PRELIMINARY DESIGN MEMORANDUM FOR FDEP CONSTRUCTION PERMIT

Citrus County Landfill Leachate Treatment Plant

Modification of FDEP Operation Permit No. SO 09-187229 for construction approval to implement process improvements for increased nitrate removal.

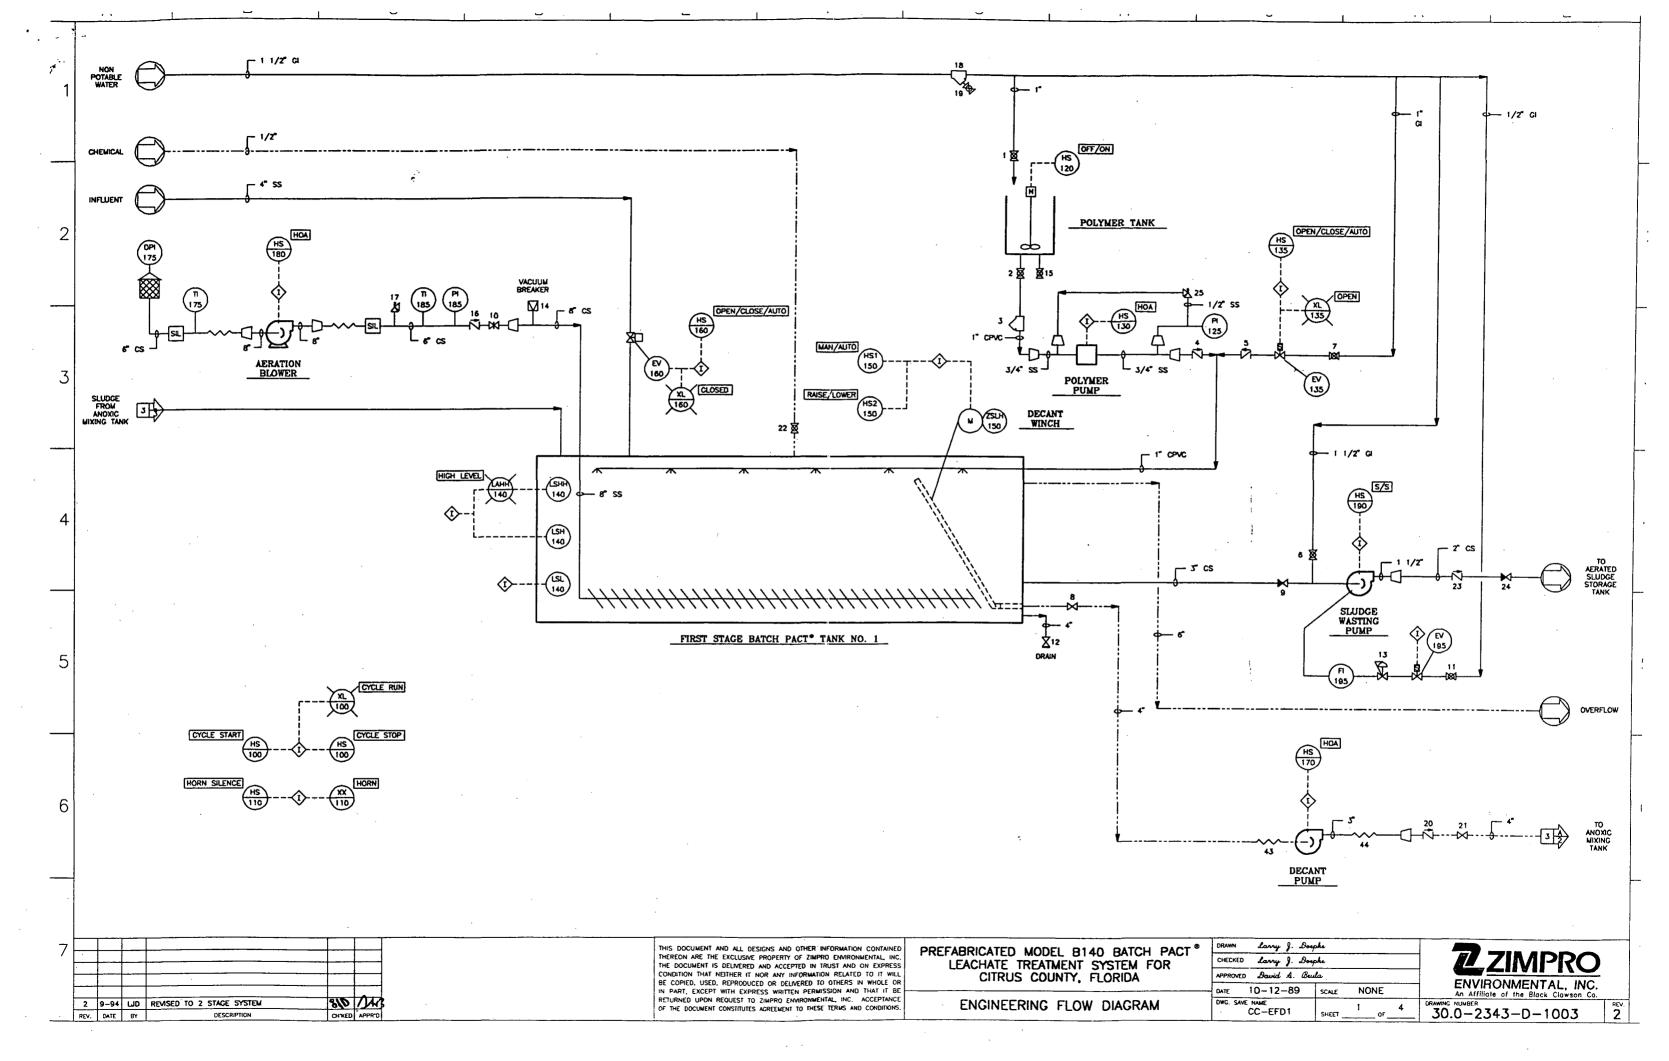
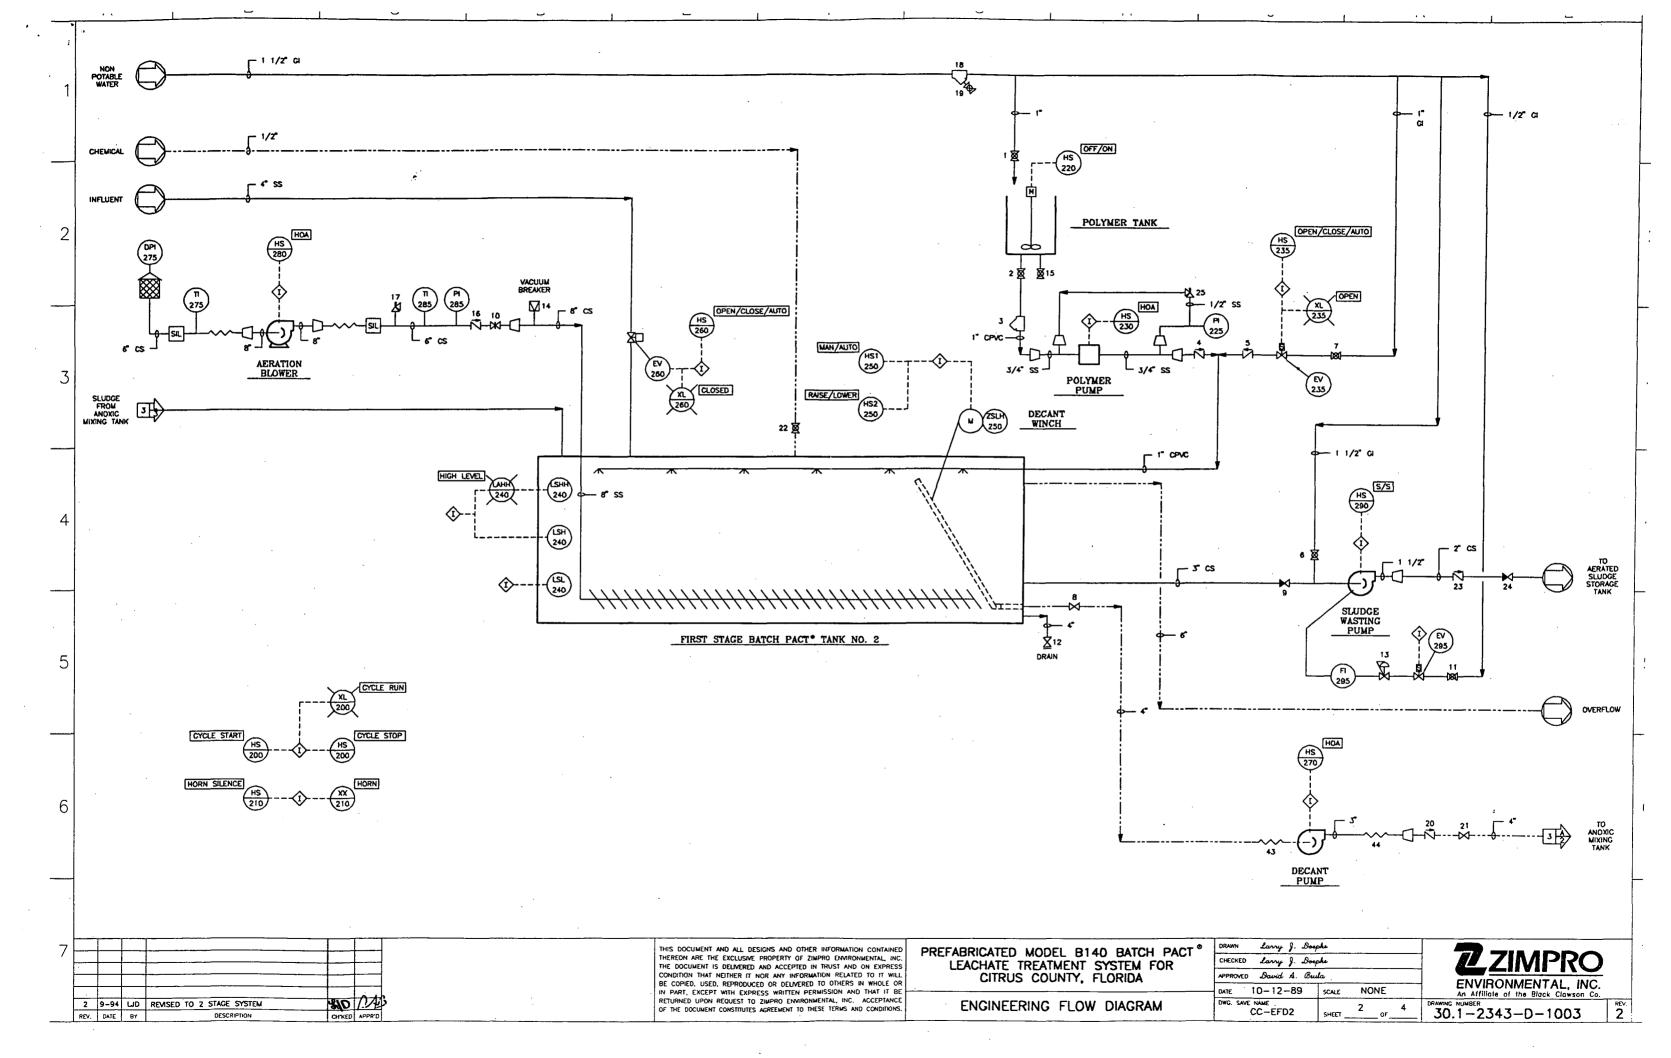
- 1. Convert Aeration Reactor No. 3 to a second stage reactor. Reroute discharge from Reactors No. 1 and 2 to Reactor No. 3 (see attached Drawing 1 of 4 and 2 of 4 with this change). Modify controls for Reactor No. 3.
- 2. Add three new mixers (3 HP each) to Reactor No. 3 to replace single submersible mixer (see attached Drawing 3 of 4 with this change). Add new access bridge and grating and hand rails.
- 3. Add methanol storage tank (1700 gal) and methanol feed pumps with piping to Reactor No. 3 (see attached Drawing 4 of 4 with this change).
